Environmental Re-evaluation

ENVIRONMENTAL
IMPACT STATEMENT

Subject: Mountain View Corridor, Salt Lake County and Utah County Final Environmental Impact Statement and Final Section 4(f) Evaluation dated September 2008; Record of Decision dated November 17, 2008

Re: Mountain View Corridor Environmental Re-evaluation #2
UDOT Project Number *SP-0067(3)0

Figure 2-2. Frontage Road Concept Cross-Sections – Salt Lake County

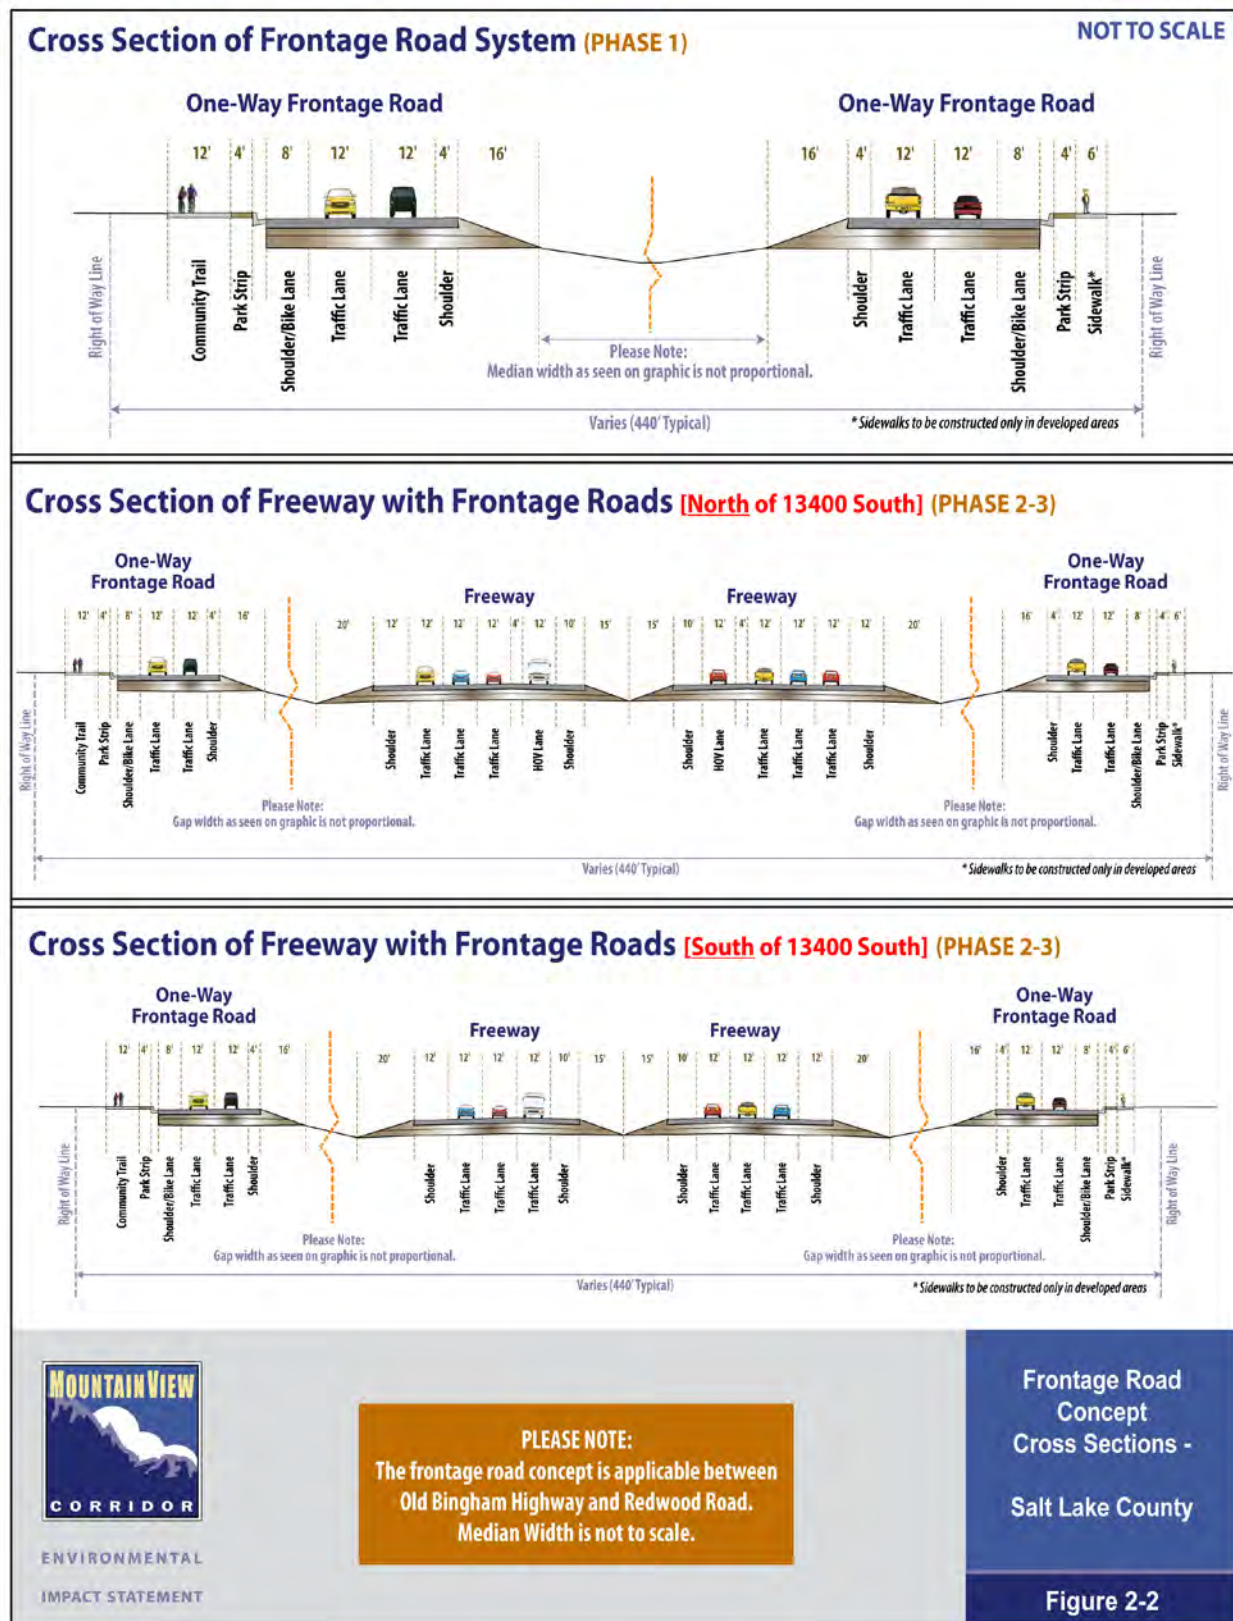
- Frontage Roads
 - The design in the Final EIS did not include the use of frontage roads in Salt Lake County. To better accommodate distribution of local traffic and connect to the local road grid system, UDOT is proposing frontage roads from Old Bingham Highway to South Hills Boulevard. These roads would operate similar to the arterials proposed in the Final EIS Phase 1 implementation plan (see Chapter 36, Project Implementation [Phasing], of the Final EIS). In full build-out (2030), the frontage roads would become one-way roads with two lanes in each direction (see Figure 2-2 below). The frontage roads would be designed to allow access to only city streets, with up to five access points per mile. No private access will be allowed.

Figure A-01

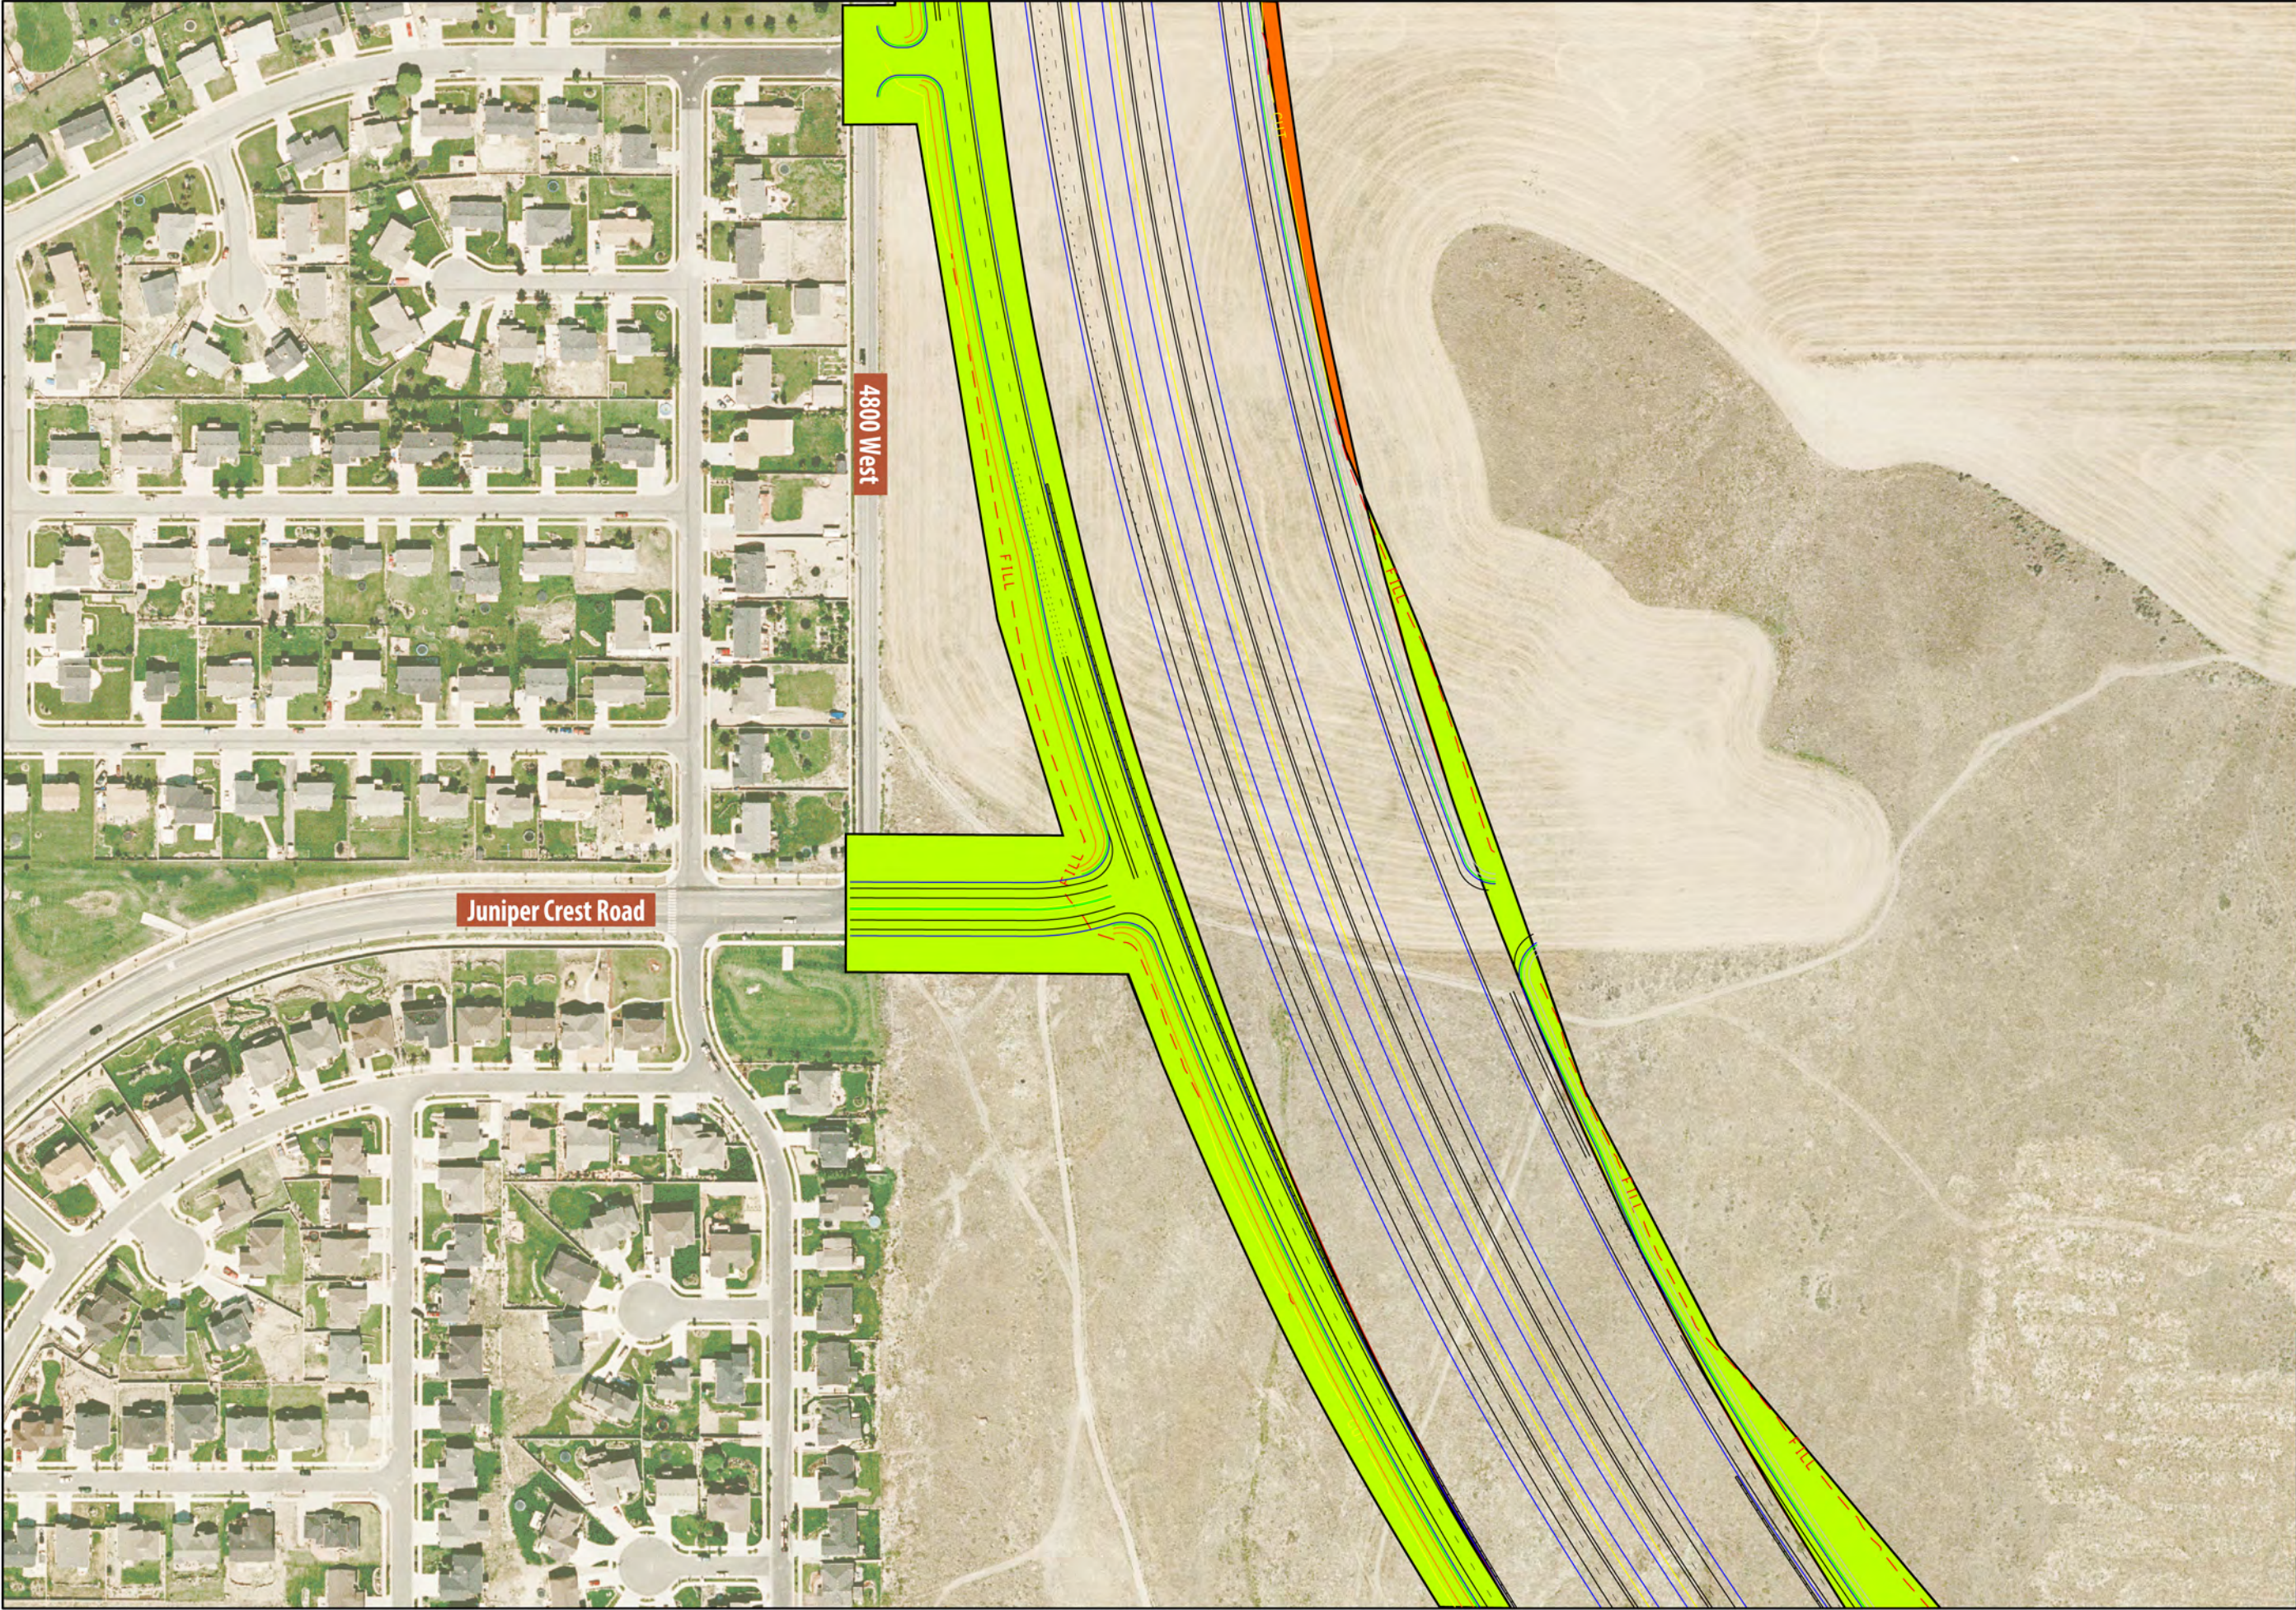
- South Hills Boulevard
 - The initial Salt Lake County project of the MVC would end just north of the Salt Lake County–Utah County line west of Redwood Road at about 16000 South. To provide access to the MVC from Redwood Road, South Hills Boulevard would need to be constructed. This road would be five lanes wide and just over 0.5 mile long. The construction of South Hills Boulevard was not evaluated as part of the 2100 North Freeway Alternative but was evaluated in the Final EIS under the Arterials Alternative as a Porter Rockwell Boulevard arterial (see Appendix A, Figure A-01).

Figure A-02

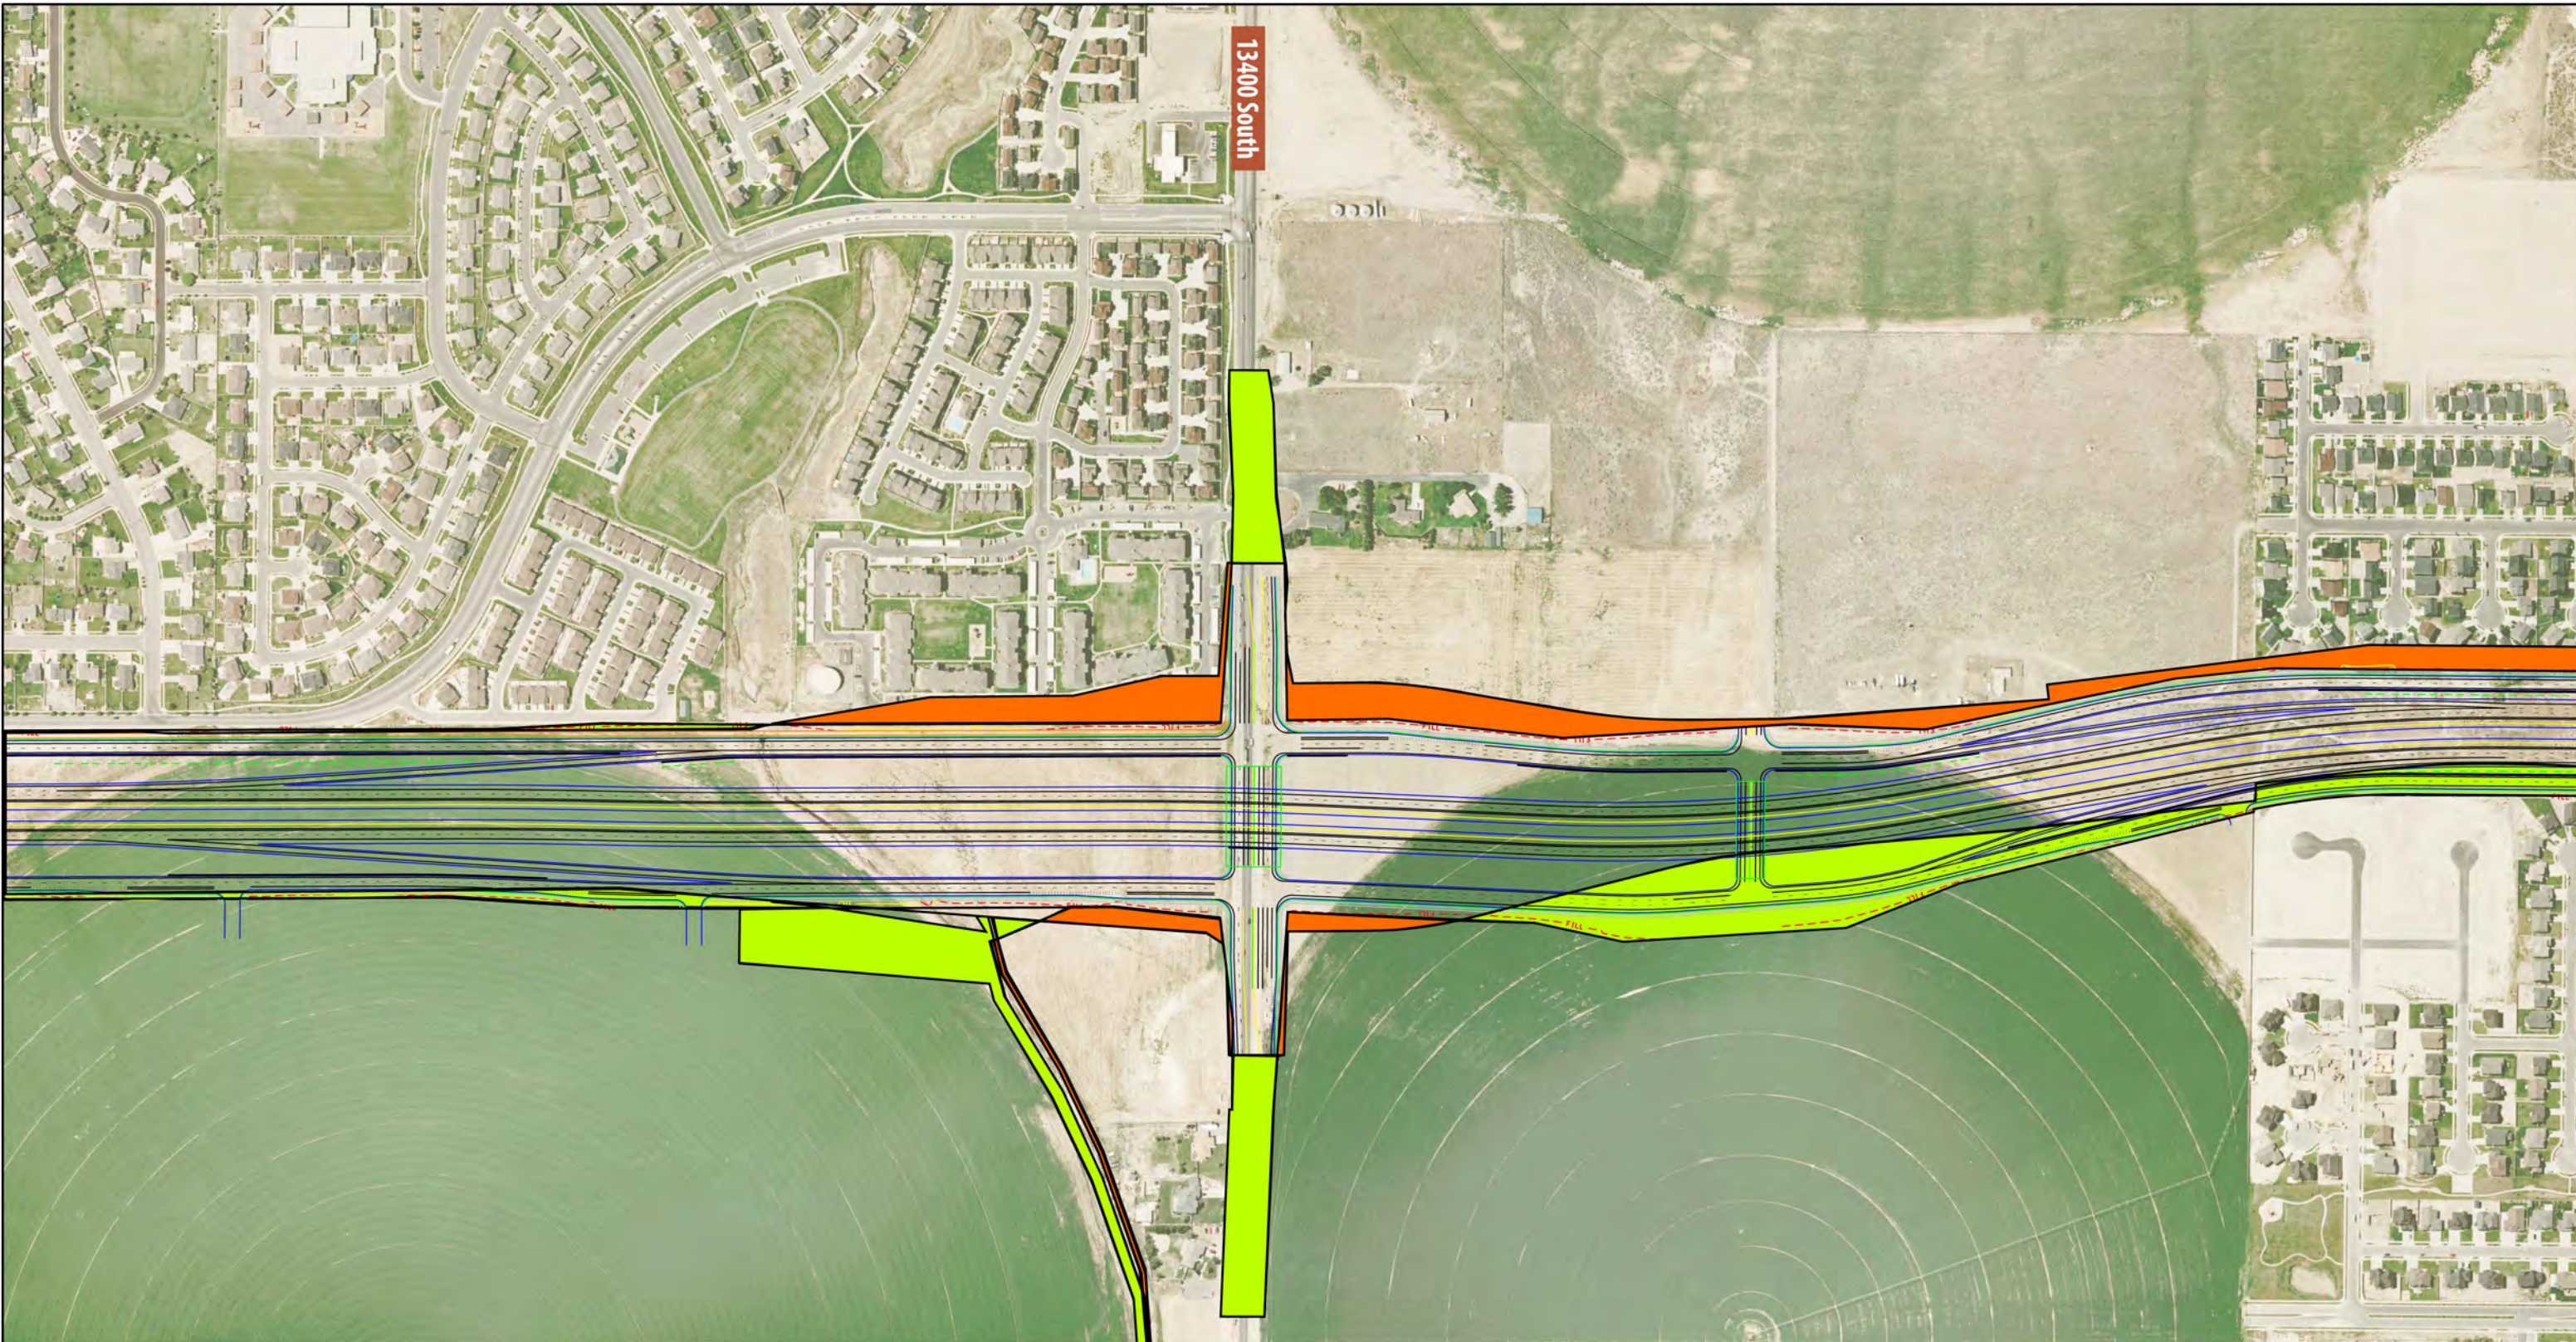
- Juniper Crest Road
 - The frontage roads would provide increased access along the MVC and would establish a road grid. This would help local traffic circulate, so there would be little additional benefit from carrying Juniper Crest Road over the MVC on a grade-separated overpass. Therefore UDOT would not carry the road over the MVC on an overpass but would connect Juniper Crest Road to the frontage roads on either side of the MVC (see Appendix A, Figure A-02).
